ENGINE OIL PUMP MEASUREMENT POSITION UPDATE

NO. TSB-89-11-007

MODEL 1988 to 1989 Models

FIGURE 1

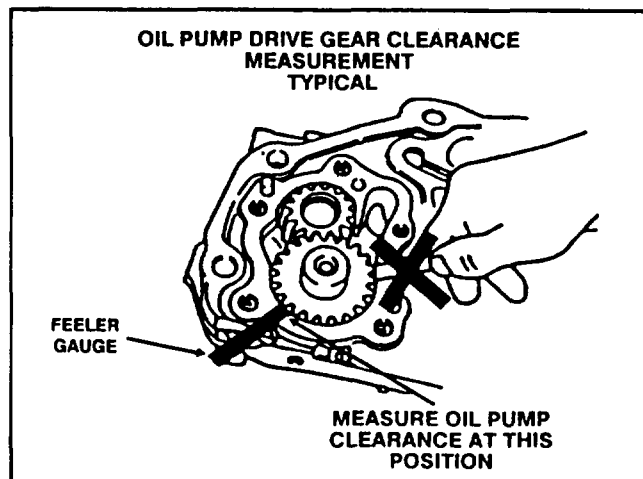
In order to increase service accuracy, the oil pump gear tip measurement position has been moved. Shown in figures 1 and 2 the correct places to measure the clearance on both the drive gear and the driven gear. Please make the indicated changes to the service manuals listed below and write this TSB number in the TSB revision boxes on the affected pages. Clearance specifications have not changed. Please refer to the Service Manual for clearance specifications.
